EDEN ELECTRONICS, INC.

P/N 110227.03

TRAVELER(+) (WT550)

POWER AMPLIFIER

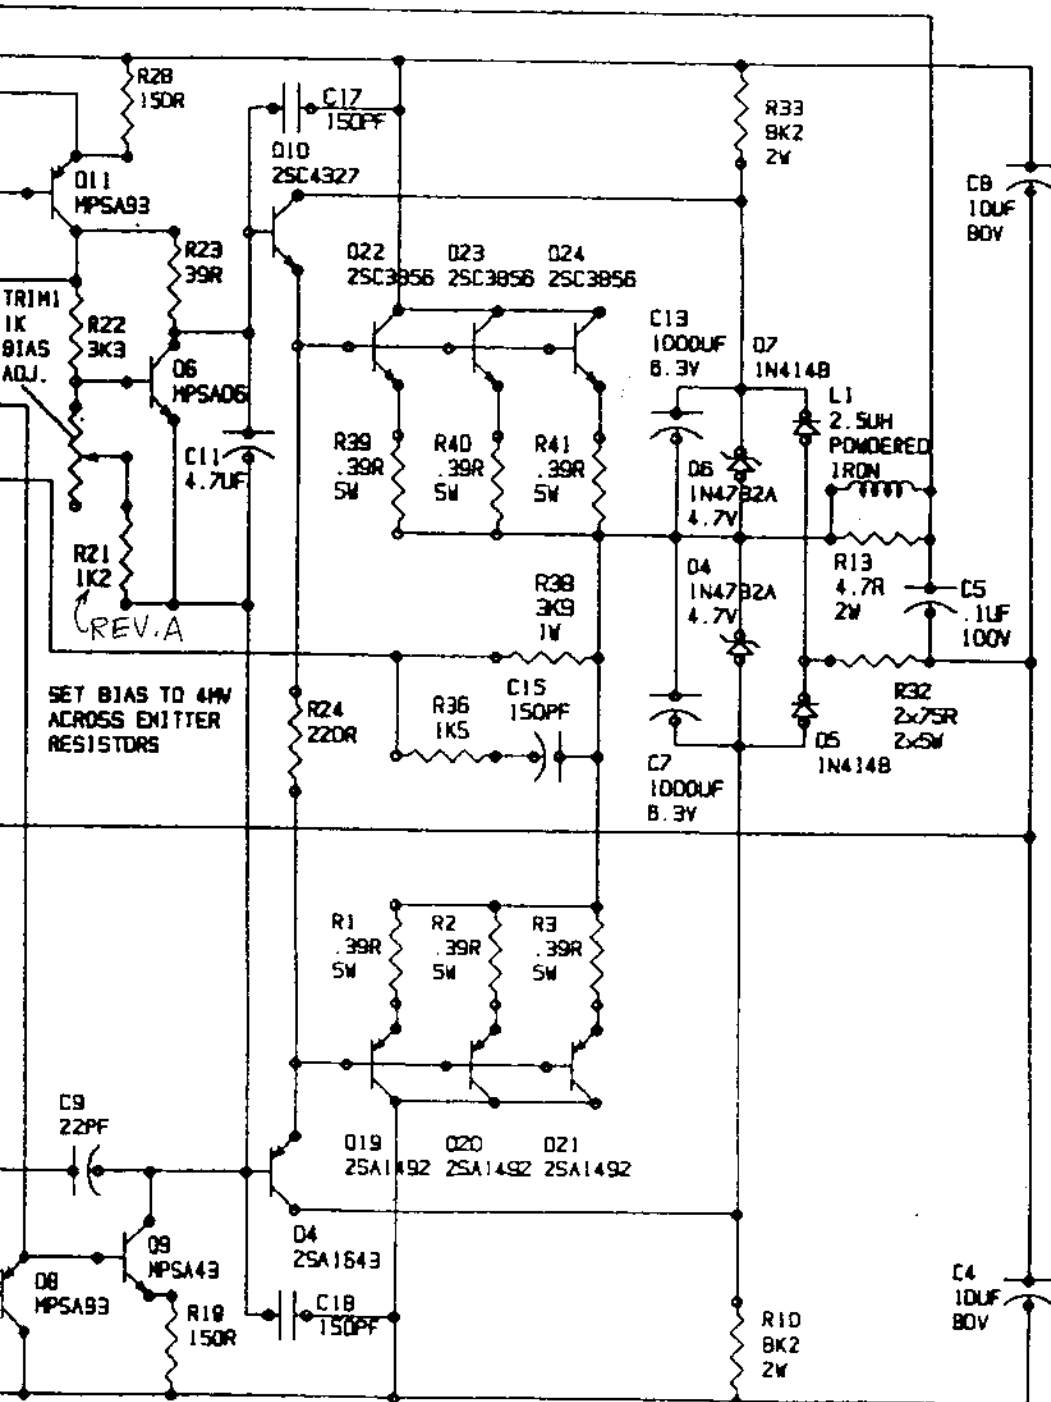
R21 CHANGED TO 1.0K2.

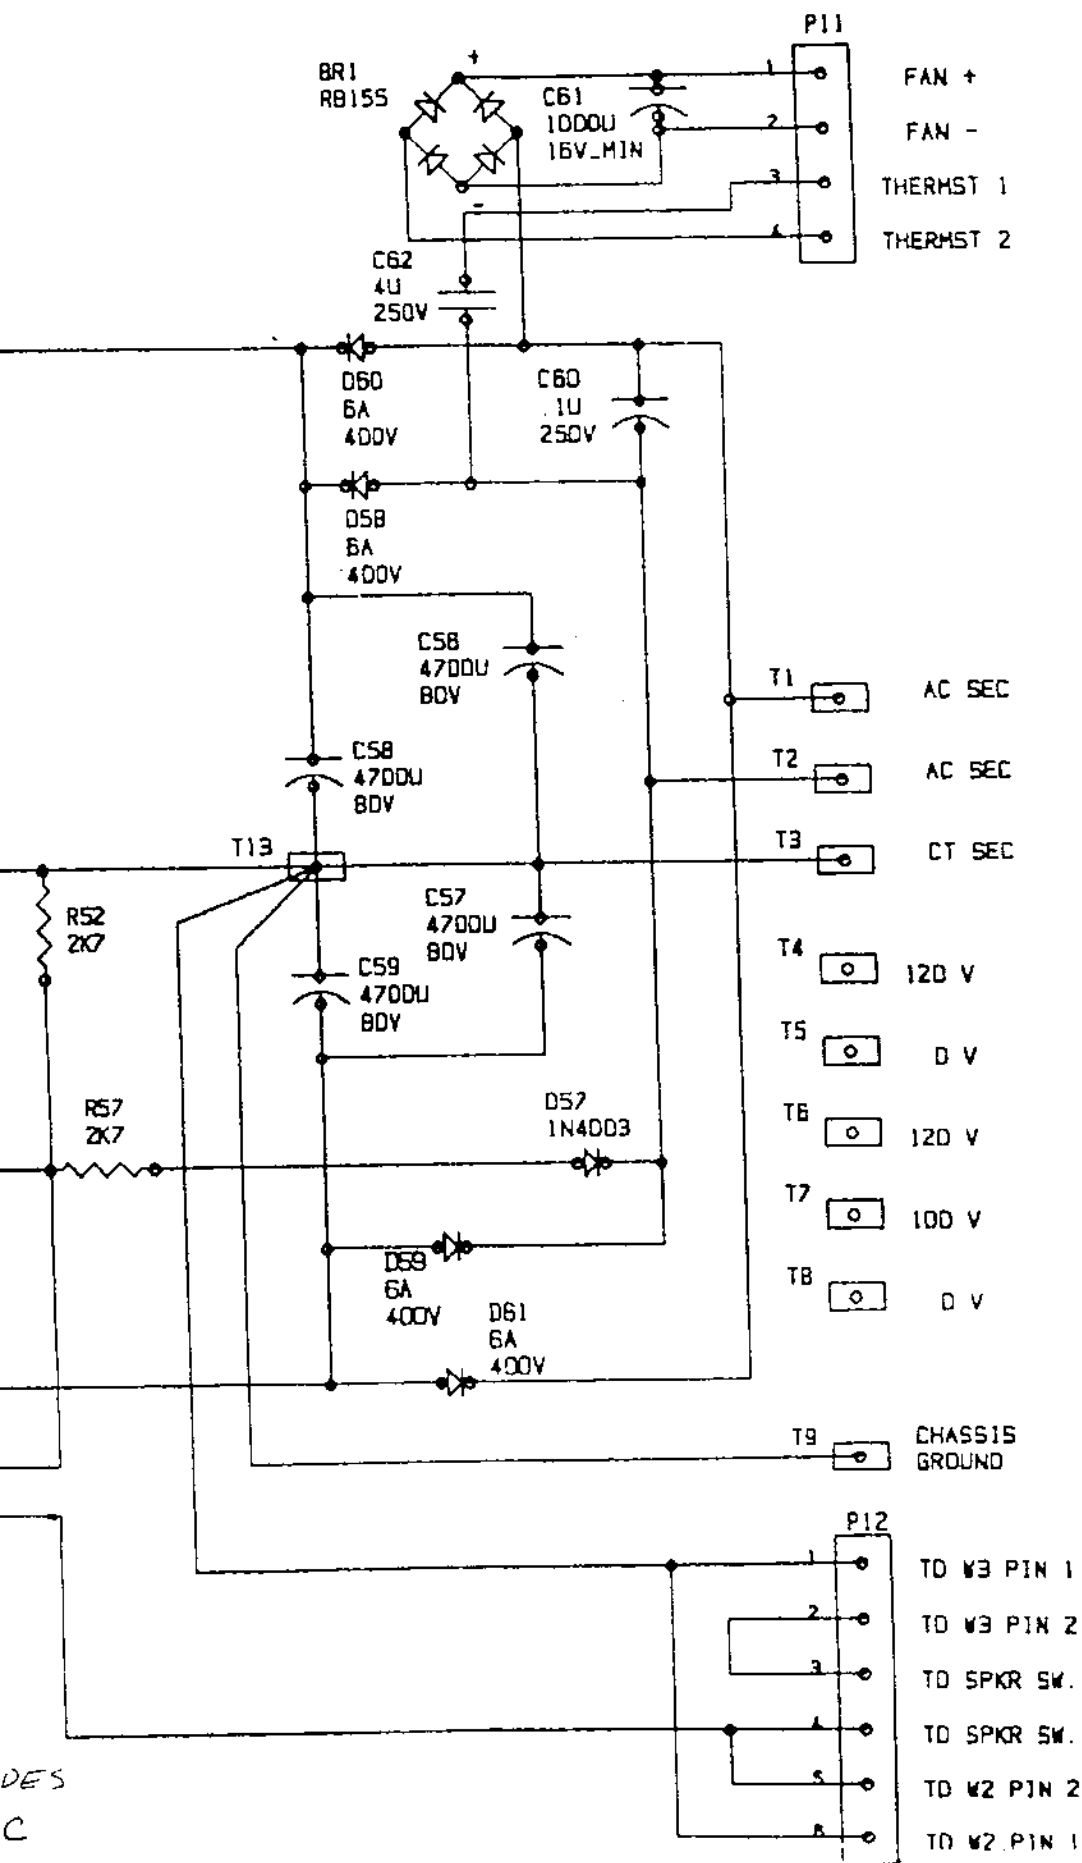
- ADD 100Ω, 1W, & 22Ω, 2W RESISTORS
- ADD 2 1N4746A, 18VZ ZENED DIODES
- CHANGE Q51 (TIP31B) TO TIP41C
- CHANGE Q55 (TIP32B) TO TIP42C
